Comment to the new French Dynamic Backset Proposal

JAPAN/ MLIT
September 2006

(2) Validity for Whiplash Injury Assessment Index

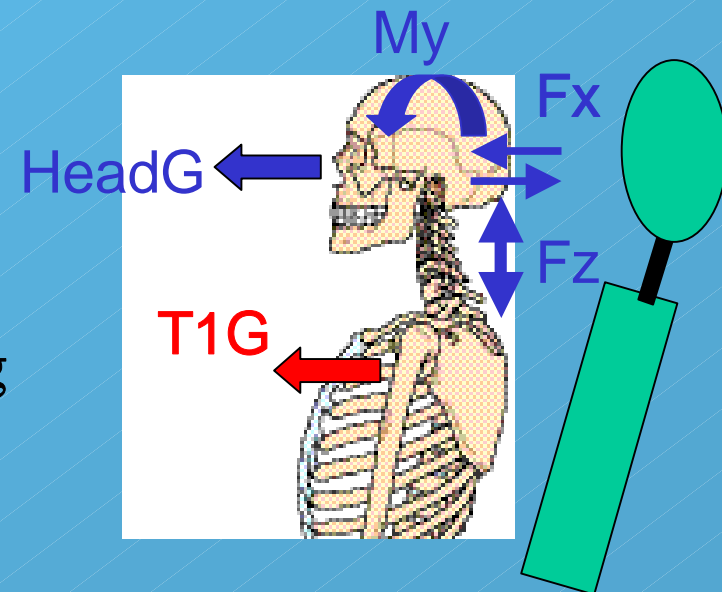
- (a) Need to examine the relative horizontal motion of the neck.

There is a possibility to represent by using the dynamic backset.

- (b) Able to determine the load on the neck by measuring the force and moment on the upper and lower parts of the neck.

Impossible to measure by using the dynamic backset.

(b) Measurement Method

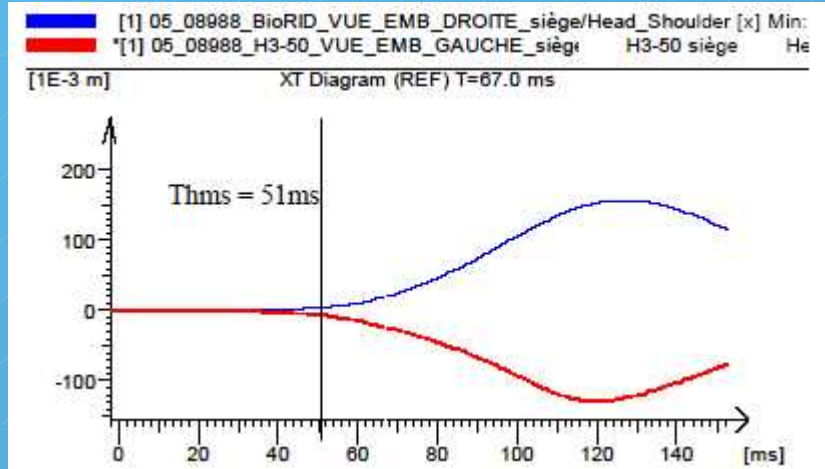
- Definition of the Time of Head Motion need to for Dynamic Backset is not clear and accurate.

(Video analyses small variation makes effect of dynamic backset value.)

⚡ Determine the Time of Head Motion relatively to the Shoulder (Thms). To consider only timing during which shearing of the neck occurred (considered to be dangerous) and to be incentive for foam deformation systems (toyota avensis) or structural one (whips)

T1 Locater

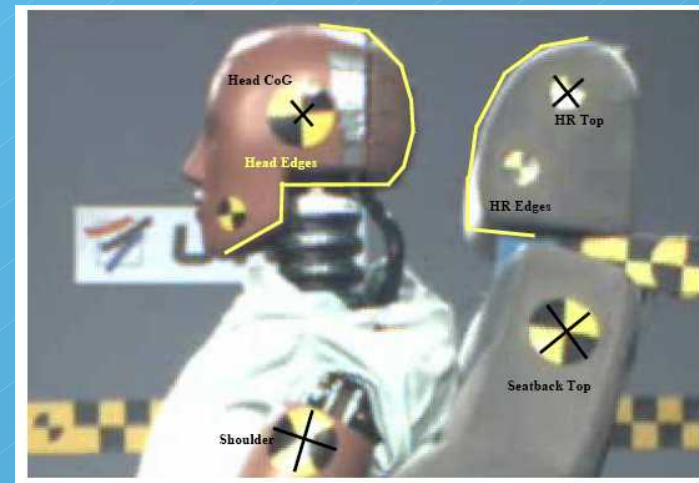
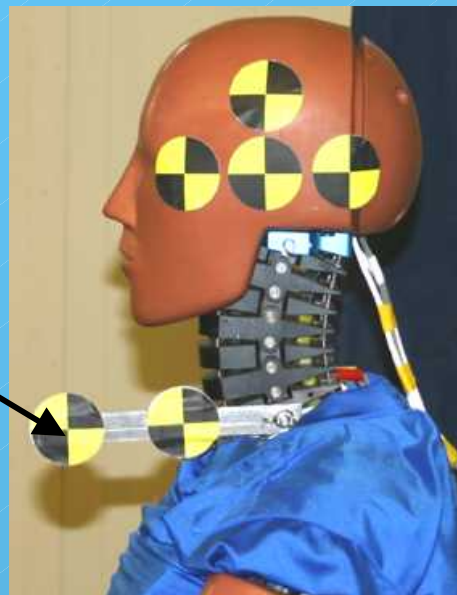
- The analysis position of the dummy torso should not be on the shoulders but on T1 equipped with a fixing bar.
(As BioRID-II's shoulders are simply attached to the skin covering the torso, the freedom of motion is excessive for the shoulders.)

(c) Issues on Dummy Setting

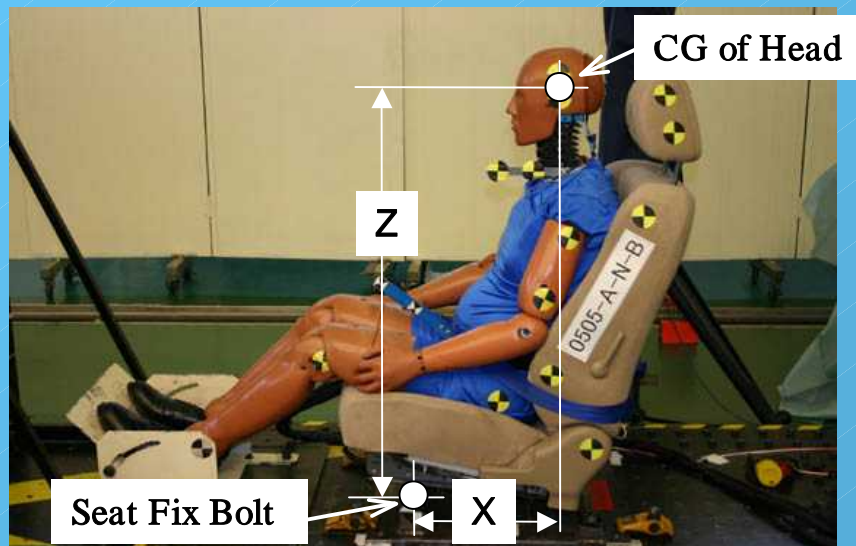
Large head position variations during dummy setting have been observed, depending heavily on testing personnel factors and seat design factors.

⇒ Need to introduce measures to reduce head position variations.

(Ex.)
Set dummy posture by using the Design HP and measure the x and z distance of CG of head from seat fix bolt.

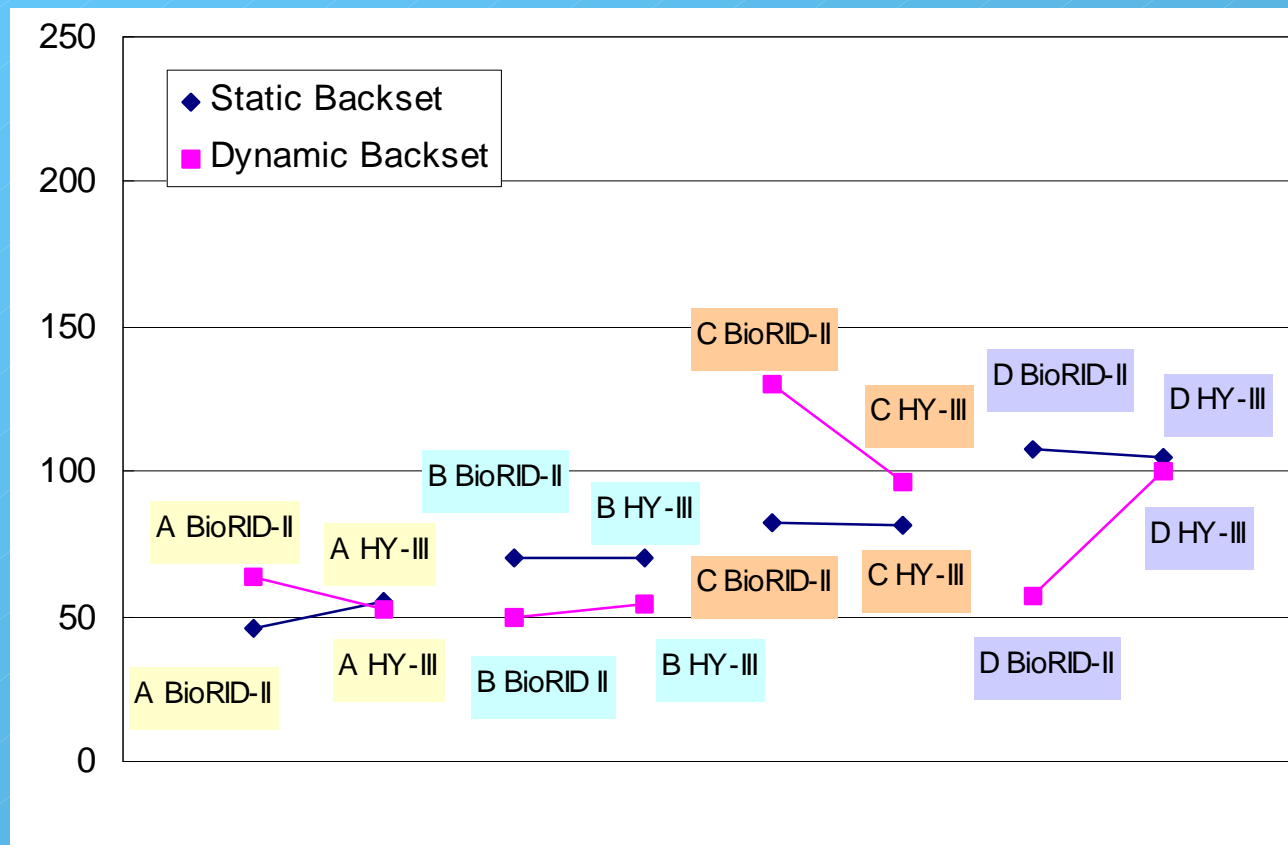
(a) Dynamic backset is not always smaller than static backset.

(b) Relation between Dynamic Backset and IIWPG Assessment

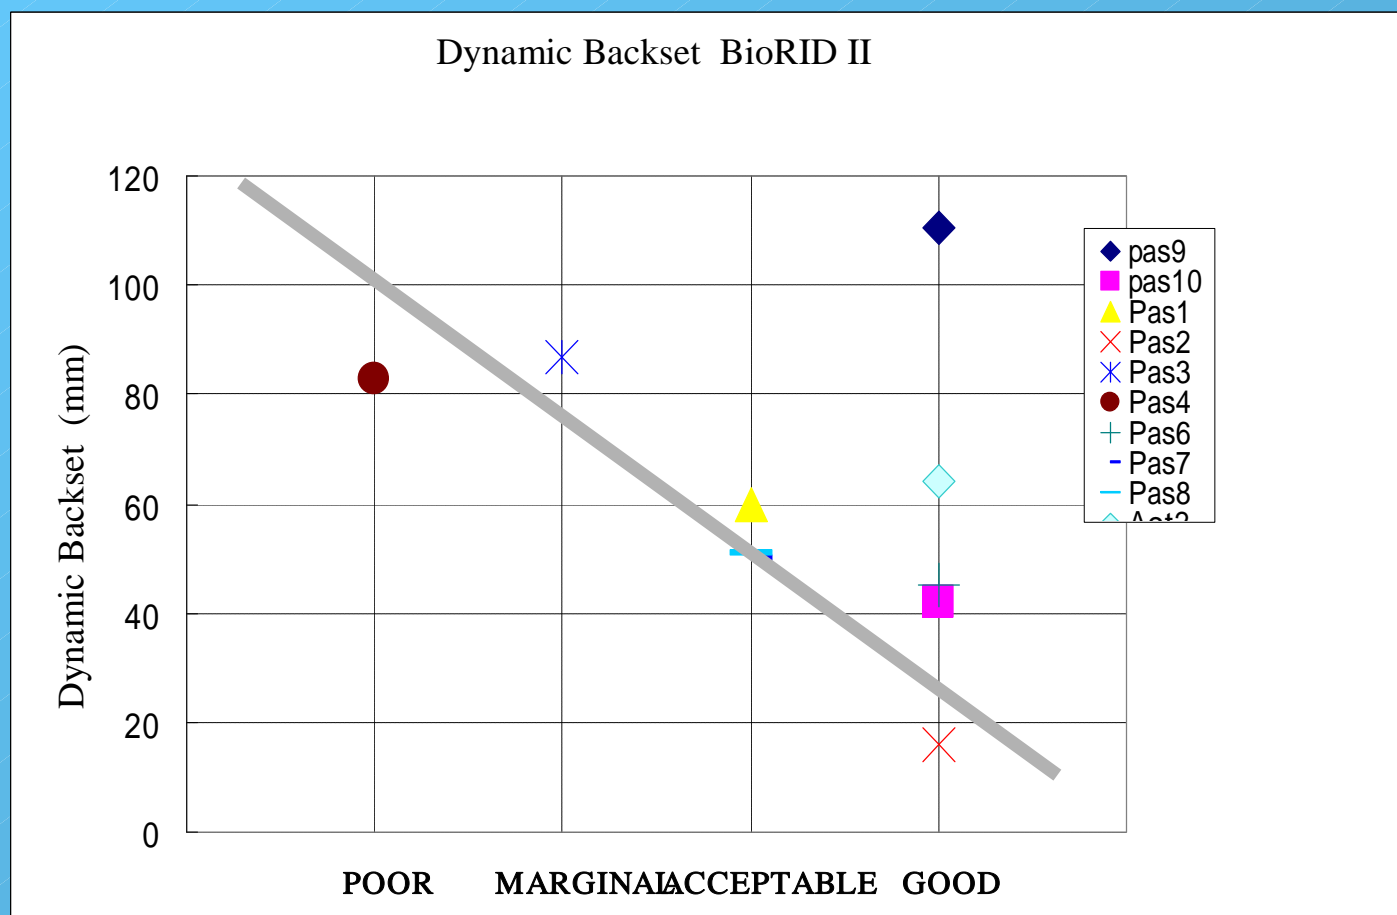
Largely correlated, but producing some conflicting results depending on seats, to require further examination
